Hiawatha Coal Company

Re: Deficiencies for Bath House Parking Lot Expansion, Bear Canyon Mine,  
C/015/0025, Task ID #3016

**Deficiency Response List**  
**Task ID #3016**  
**Bath House Parking Lot Expansion**

SECTION E-E'  
 Parkinglot Expansion

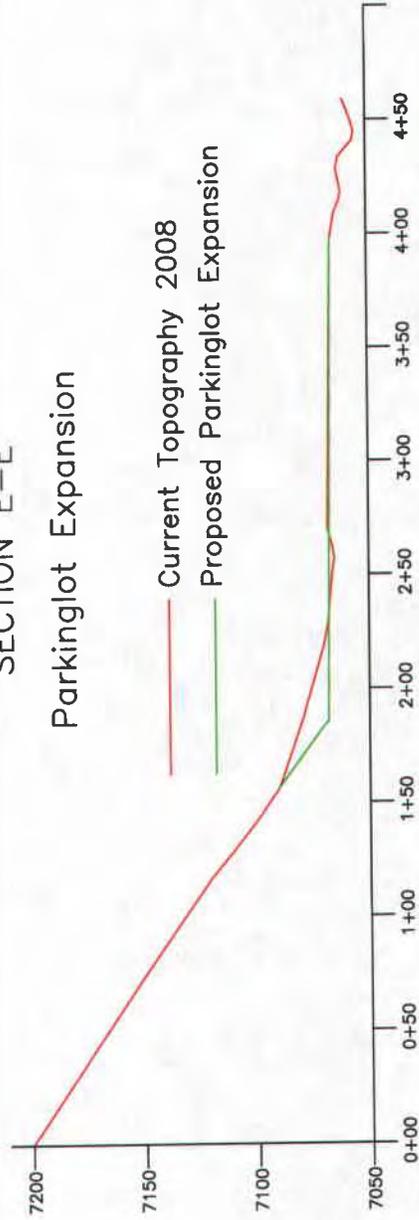
- D. The permittee must provide the Division with a map that clearly indicates sufficient slope measurements or surface contours to adequately represent the existing land surface configuration of the proposed permit area for at least 100 feet beyond the limits of mining disturbance.**
- R. Please refer to the revised Plate 2-3B, which shows extended topography to the west and a cross-section E-E' located on Page 5I-78 also included in this response.

**Figure 7-15A Cross-Section A-A' Culvert C-14D**

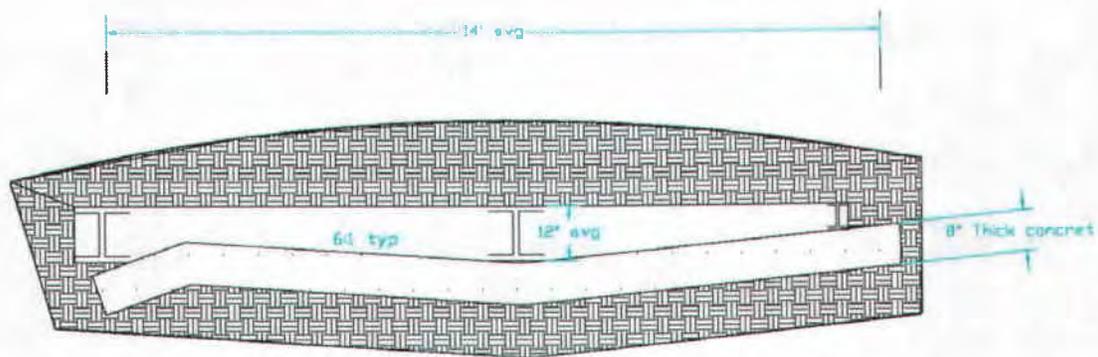
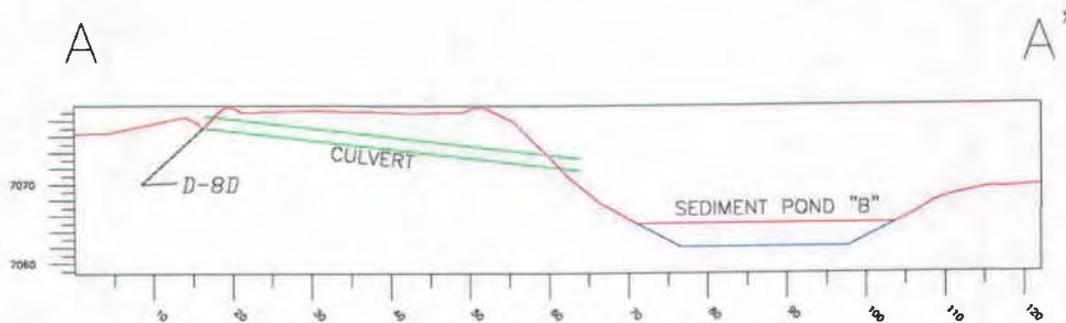
- D. The Permittee needs to modify the language on page 7-135 that describes culvert C-14D. The Language should make it clear to the reader as to what is currently in use at the site. Future tense is utilized in describing the 8" concrete slab associated with the removed water bar.**
- R. Please find the revised page 7-135 with the corrected language attached to this response.
